Peer Review File

A net-zero emissions strategy for China's power sector using carbon capture utilization and storage

REVIEWER COMMENTS

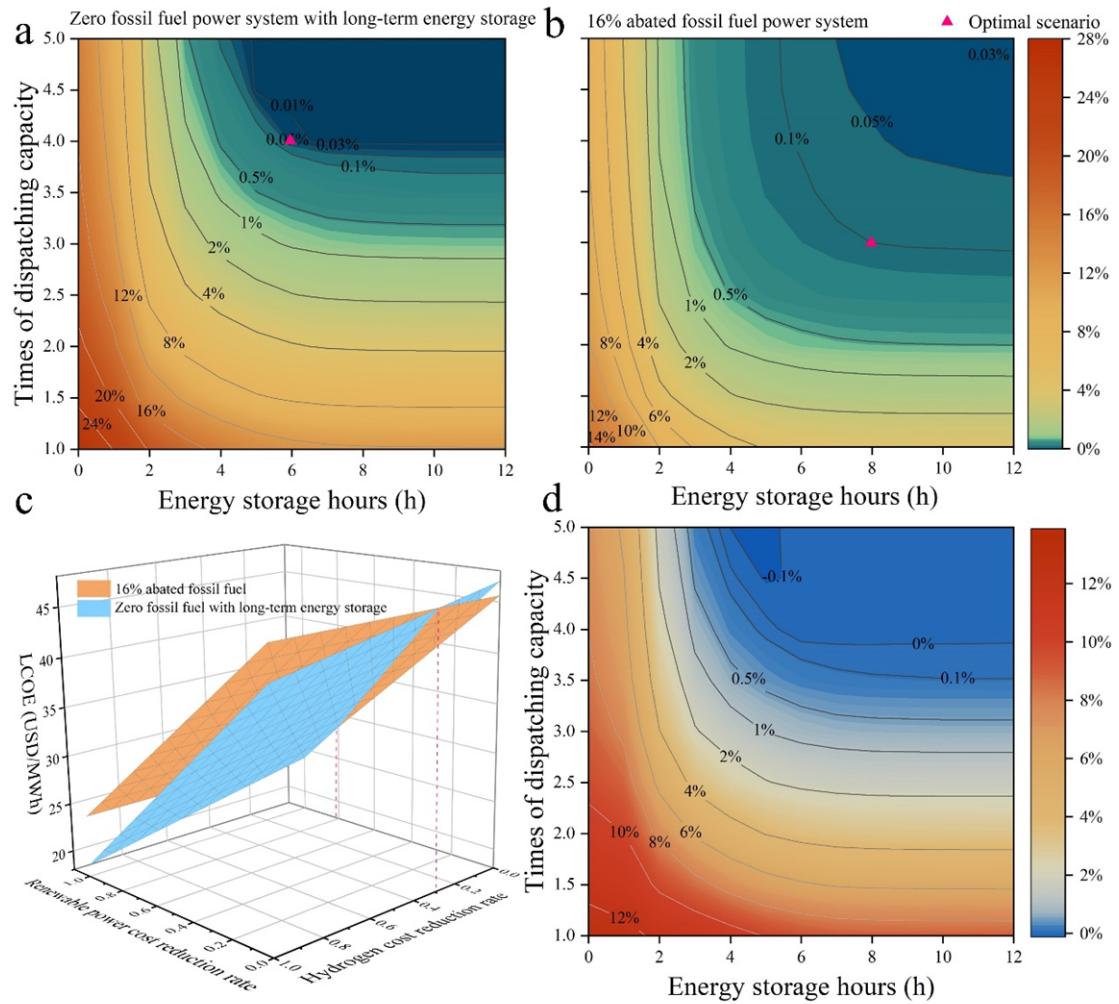
4. The authors' conclusion 1, that CCS would reduce energy shortage compared to 0-FF system is not clearly justified. An 0-FF system can supply energy with no shortage if enough storage is included; the question is how much storage is required and what it will cost. The question that should be answered is whether RE(+storage)+CCUS can provide energy with no major shortages at a lower

The results show that from the power shortage perspective, the implementation of long-term hydrogen storage in a zero fossil fuel power system (i.e., zero fossil fuel with long-term hydrogen storage scenario) can also achieve a rather low power shortage comparable to or even stronger than the fossil fuel with CCS scenario. For instance, with over 4 times dispatch capacity and over 6 hours short-term energy storage, the zero fossil fuel with long-term hydrogen storage scenario could achieve a relatively lower power shortage (<0.03%) than the 16% fossil fuel with CCS scenario with the same dispatch capacity and short-term storage hours (<0.09%). However, from the cost perspective, in order to achieve a 0.1% power shortage (corresponding to China's power system reliability standard), the minimum costs of the power system with the zero fossil fuel with long-term hydrogen storage will be 19.3% (LCOE 3.72%) higher than the power system with 16% abated fossil fuel, which are \$820 billion (LCOE 47.15 USD/MWh) and \$662 billion (LCOE 45.64 USD/MWh), respectively. This shows that the power system involving a certain ratio of fossil fuel with CCS can facilitate its reliability standard at a relatively lower cost than complete zero fossil fuel with long-term hydrogen storage. Nevertheless, if the power system reliability standard was further enhanced, the long-term hydrogen storage would play a more important role than abated fossil fuel with CCS. For example, for the 0.01% power shortage, the least LCOE of the power system with zero fossil fuel with long-term hydrogen storage will become 47.19 USD/MWh, which is 2.1% lower than that of the power system with 16% fossil fuel with CCS at the same power shortage (48.21 USD/MWh). Therefore, the long-term hydrogen storage technology is a visible alternative for significantly improving power system reliability to a much higher power system reliability standard than current, and we have highlighted this conclusion in the main text.

zero fossil fuel power generation with long-term energy storage. “*The results show that, a minimum combination of dispatch capacity and short-term energy storage is required to ensure a rather low power shortage rate under zero fossil power system with long-term hydrogen storage as with all other scenarios. For instance, meeting the 0.1% national entire power shortage rate with the least cost necessitates the construction of 6 hours of short-term energy storage and 4 times of reference dispatch capacity (Supplementary Figure S6a), corresponding to the systemic cost of \$820 billion and the levelized cost of 47.15 USD/MWh, which are respectively 19.3% and 3.2% higher than the scenario of high renewable with 16% abated fossil fuel power generation (Supplementary Figure S7).*”

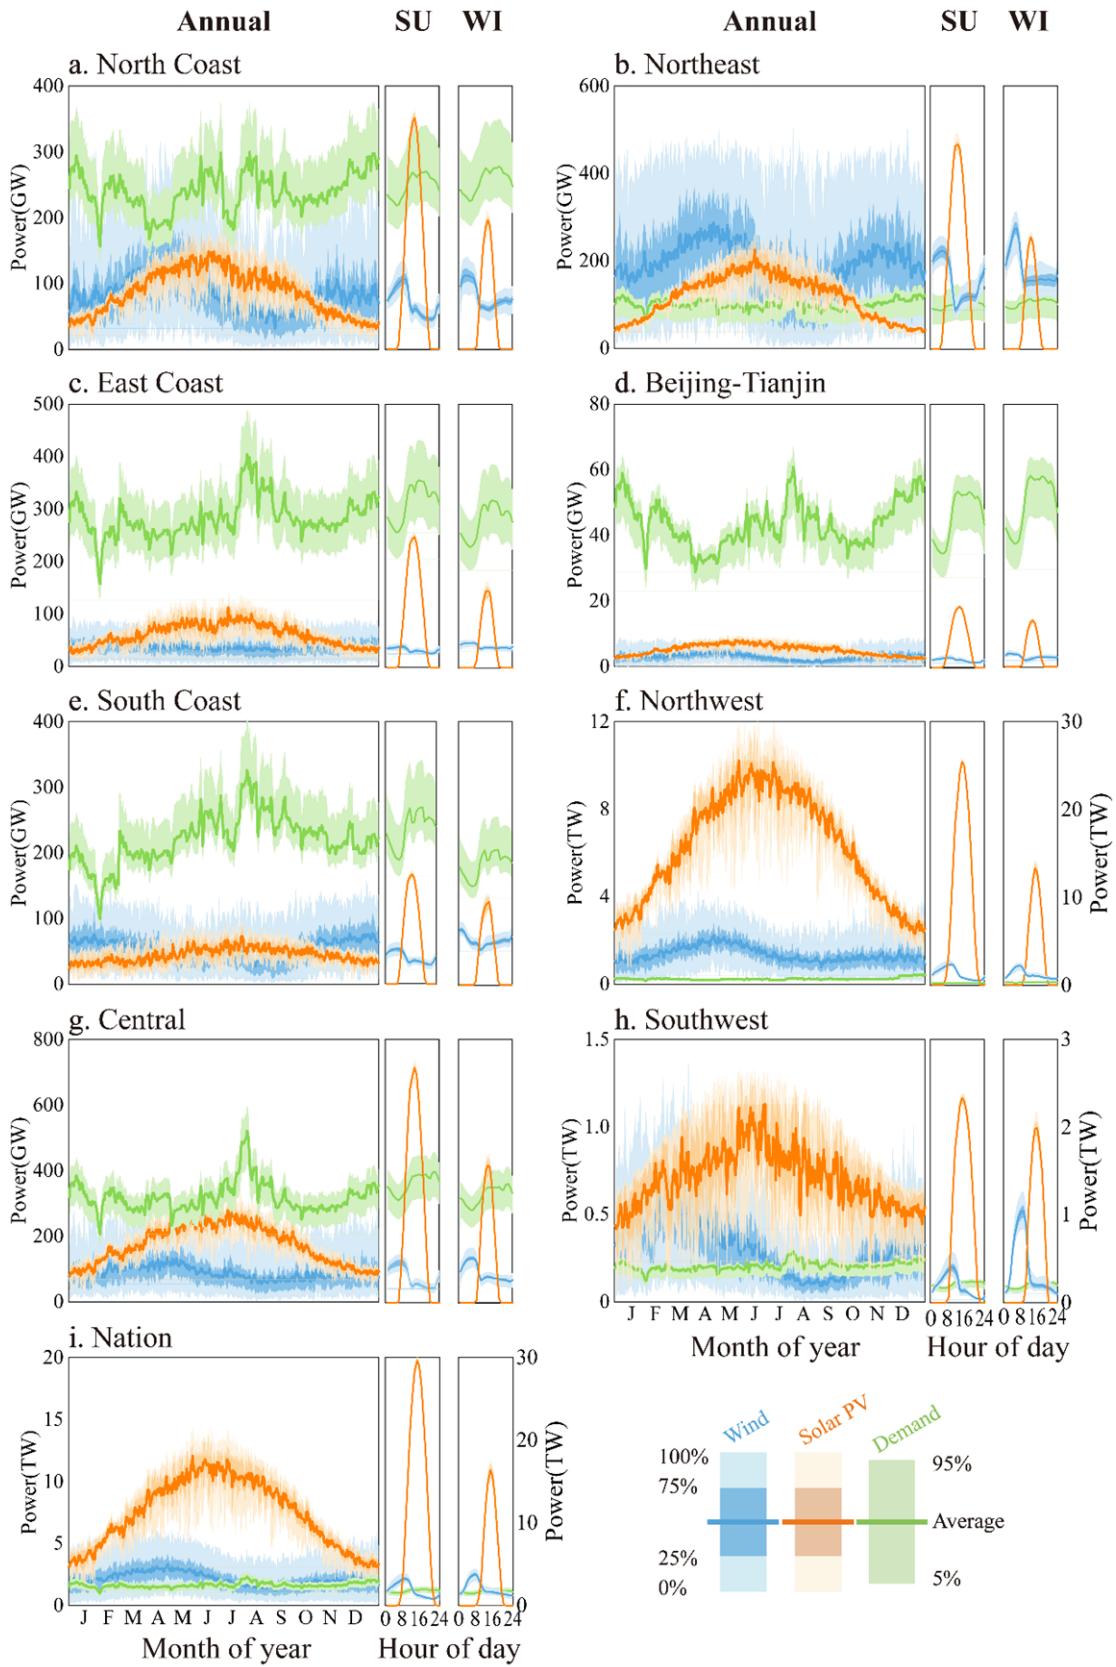
13. Pg. 8 Fig. 1 - It may be a good idea to create an aggregated figure for the entire China region where RE resources are also aggregated. This would provide a sense of how the system would potentially perform over the whole country.

Authors' Response: Thank you for your helpful suggestions. In this revised version, we have incorporated the national daily and hourly variations of wind power and solar PV resource potential and projected electricity demand in 2050 as a subfigure in Fig. 1. Meanwhile, the calculation of all indicators (e.g., power generation, electricity demand) in Fig. 1 has been presented in detail in methods.

In the revised version, we have added Fig. 1i in Fig. 1 and relevant descriptions in the ***Unmet electricity demand in a zero fossil fuel power system in 2050 China*** section in **Results** as follows.

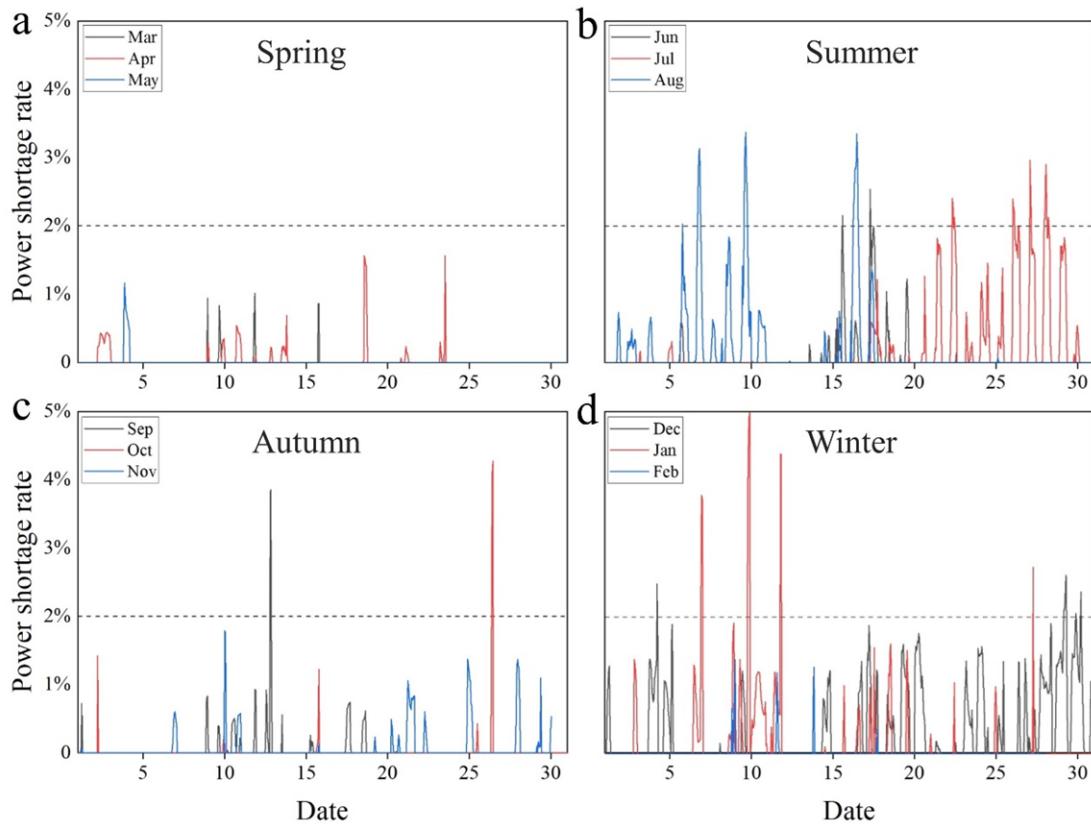
3. The reliability of the power system also needs to consider the real-time power balance among regions, including the following aspects, such as the analysis on steady state of the power system (when each node in the power system constructed in the article loses 10% of power generation or load, does the system have enough margin to automatically restore the steady state? The discussion about the oscillation period, in brief, the Lyapunov's observability and controllability proof need to be added in the model.

Steady state of optimal power system under normal weather. How the power system can be restored to a steady state under various power shortage rate over 2% is shown in Supplementary Figure S13. In terms of observability of Lyapunov stability, 54 of 8760 hours own the national real-time hourly power shortage rate larger than 2%, with 2-3% for 36 hours, 3-4% for 11 hours, 4-5% for 6 hours, and more than 5% for 1 hour, and with 0, 32, 4, and 18 hours of national hourly power shortage rate greater than 2% in spring, summer, autumn, and winter, respectively (Supplementary Figure S13). In terms of controllability of Lyapunov stability, the fluctuation period for power shortage rate more than 2% is generally between 6 pm and 7 am. The power system can be restored to a steady state in a maximum of 7 hours when the fluctuation period is from 6 pm to 11 pm, whereas it can be restored in a maximum of 5 hours when the fluctuation period is from 0 am to 6 am (Supplementary Figure S13). This indicates that under normal weather conditions, the power output variation has little and short impacts on the electricity supply, which enables the optimal power system easily to return to a stable state.

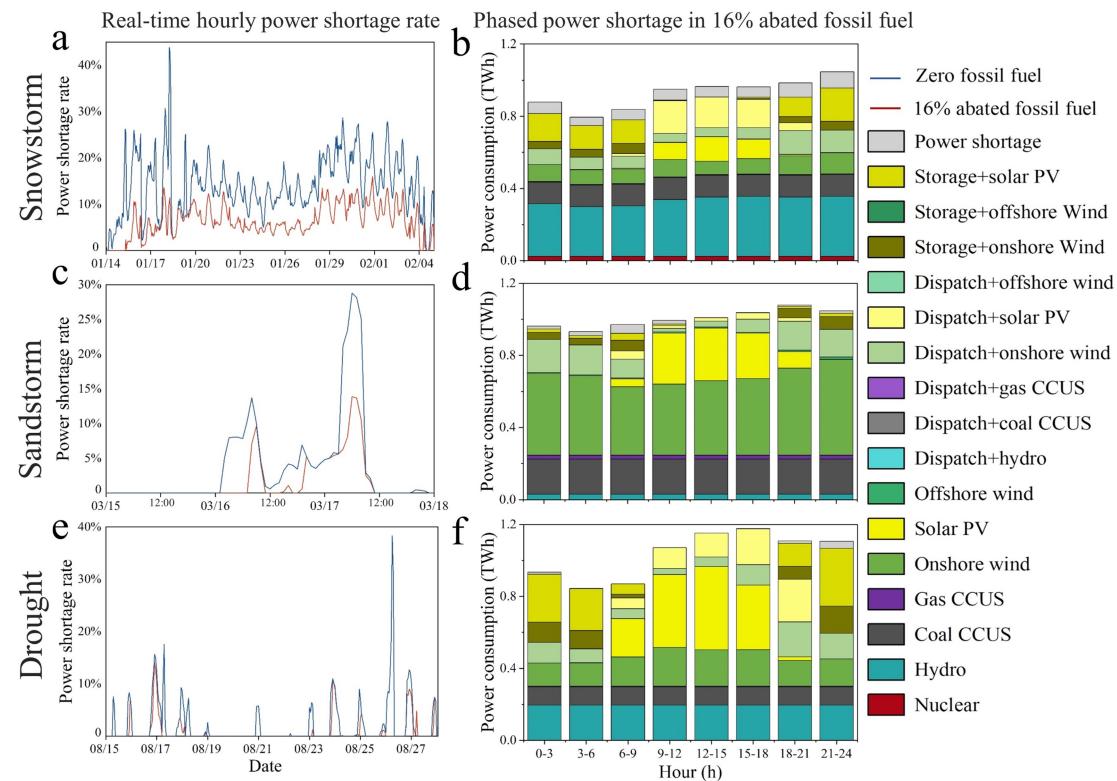
4. In the model and simulation of the impact of extreme weather events, the manuscript only simulates the loss of above 220kV lines within the province. However, the loss of inter-provincial lines was also serious during the 2008 snow disaster, which should also be discussed in the manuscript.

..... Importantly, incorporating abated fossil fuel power generation could significantly alleviate extreme power shortage at certain moment during weather occurrences. For instance, the greatest hourly power shortage rates with zero fossil fuel power system under snowstorms (43.9%), sandstorms (28.8%) and droughts (38.3%) would be reduced by 33.2, 14.9 and 38.3 percentages under 16% abated fossil fuel power generation system (Figure 4a, 4c and 4e).

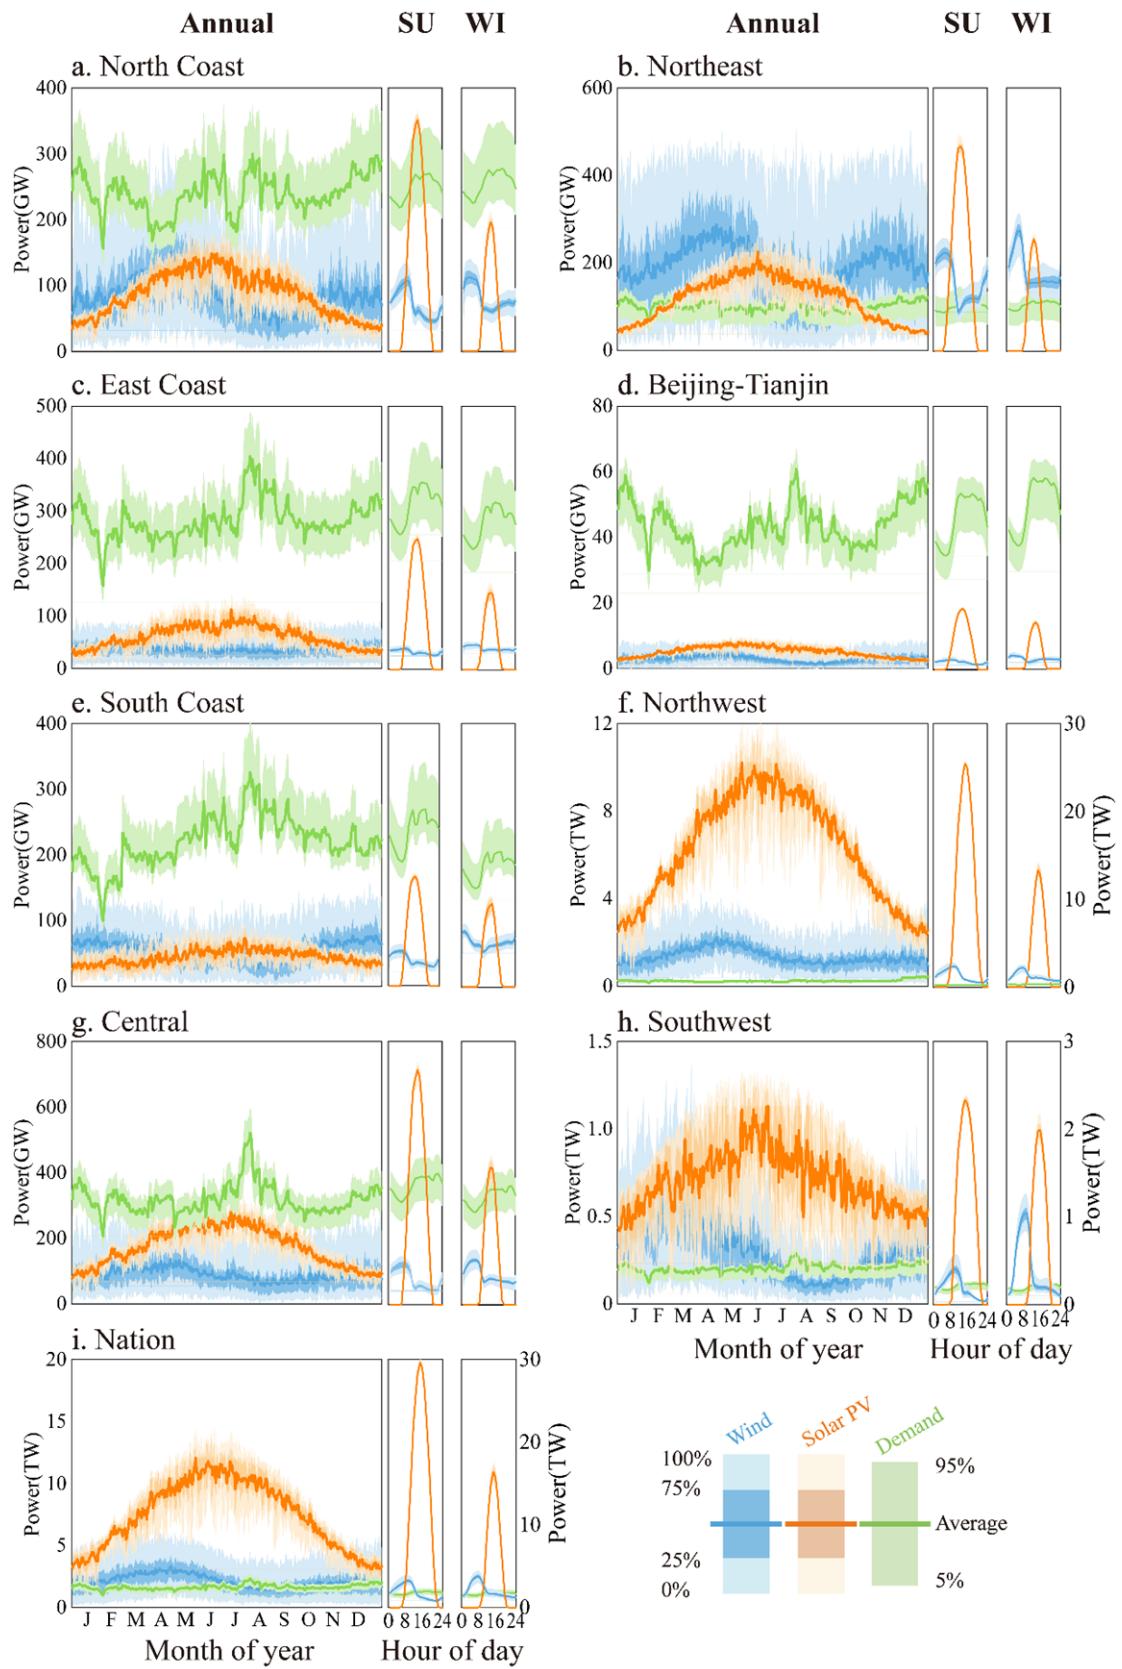
2. Figure 1 is outstanding. However, the legend parts are a bit small for the reader. Especially if the reader has some age, you could move this legend to the left side of Figure 1g or describe them in a separate space.

Authors' Response: Thank you for your careful suggestion. We have adjusted the relevant figure and separated the legend. The specific modifications are shown as follows.

Fig. 2 The relationship between national entire power shortage rates, transmission capacity, and short-term energy storage hours.

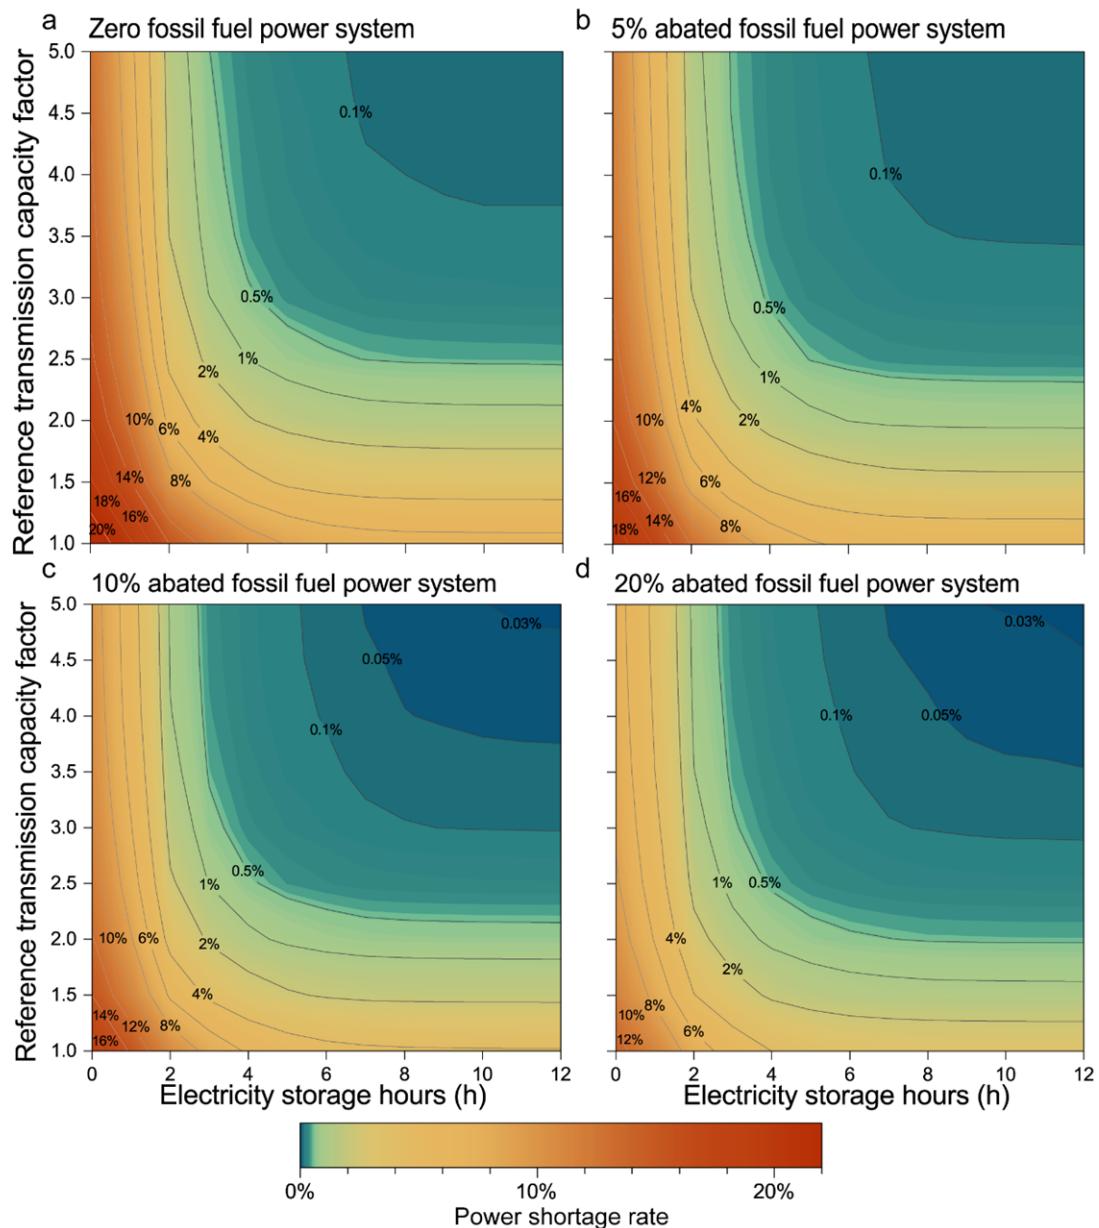
15. Pg. 11 Fig. 2 and Ln 245- 247. Given the lack of Hydrogen inclusion in the analysis as noted in the previous comment, the claim that it is essentially impractical to operate an 100% RE system in China is invalid. It is clear that some kind of longer-term buffer is needed. By excluding this option (hydrogen and operating the pumped hydro only for 12 hour storage), the authors are forcing the conclusion that CCUS (the only other alternative) is needed. Unless, the hydrogen option is included and discussed, the paper’s conclusions will not have any practical validity.

“.....Overall, a fully non-fossil power system will have difficulty achieving satisfactory power reliability in 2050 unless short-term energy storage and dispatch infrastructure is well developed (as indicated by the limited area of colder color representing less than 0.1% national entire power shortage rate shown in Figure 2a) or long-term storage is included (see analysis afterward).”

Authors' Response: Thank you for your careful comments. Based on your suggestion, we have modified the y-axis titles of both Figure 2 in the main text and Figure S6 in the supplement. In addition, we have kept the term statement "transmission" with necessary changes in the main text.

Figure S12. Hourly electricity load curves for typical workdays and non-workdays in representative provinces of eight regions.

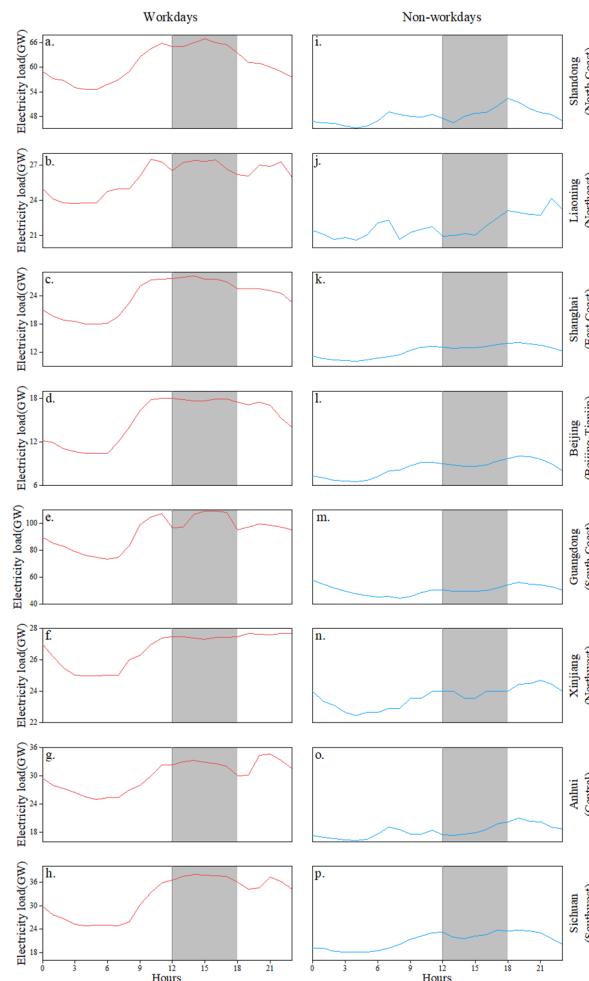
2. Using the Anhui province as reference for reconstructing the hourly demand of the other provinces is a bit surprising to this reviewer (would have expected that this data should be available). Since, evidently they are not, it would be at least a good practice to time-align the demand of other provinces with the local time so that the overall effect is more realistic (e.g. when demand peaks in the East during noon, the solar output of the West would be low being a few hours delayed).

In summary, our analysis has addressed your concerns by capturing the hourly variation characteristics of each day both for provincial electricity consumption and variable renewable power output potential that are consistent with the local time scale of each province.

In the revised version, we have added Figure S12 in *Supplementary Figures* as follows and cited it in the *Method* section.
